CONFIDENTIAL
DRAFT

Safety Recall 70F – Toyota Camry All Weather Floor Mat Accessory for 2007 and Early 2008 Model Year Vehicles

Toyota Camry All Weather Floor Mat Involved in this recall

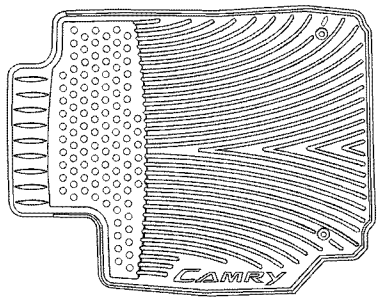
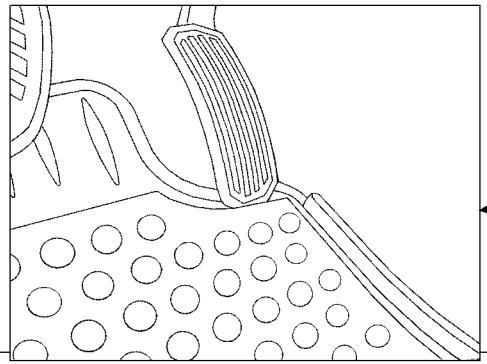
If the Toyota Camry All Weather Floor Mat is not **secured by the retaining hooks (clips)** and the mat moves forward, it may interfere with the accelerator pedal.

- In recent months, Toyota has received reports regarding the optional Toyota Camry All Weather Floor Mat (floor mat constructed from heavy duty rubber) slipping forward and interfering with the movement of the accelerator pedal. Toyota has investigated these reports and determined that if the optional Toyota Camry All Weather Floor Mat (either by itself or if it is placed on top of an existing carpeted floor mat) is **not secured by the retaining hooks (clips)** and the mat moves forward, it may interfere with the accelerator pedal returning to the idle position. If the mat is properly secured, it will not interfere with the accelerator pedal.

- A newly designed replacement driver's seating position All Weather Floor Mat will be available in approximately mid-to-late Nov. 2007. Until the replacement floor mat is ready, a preliminary owner notification letter will be sent to vehicle owners requesting their assistance in regularly verifying the floor mat is properly secured using the retaining hooks (clips) provided. If the mat is properly secured, it will not interfere with the accelerator pedal.
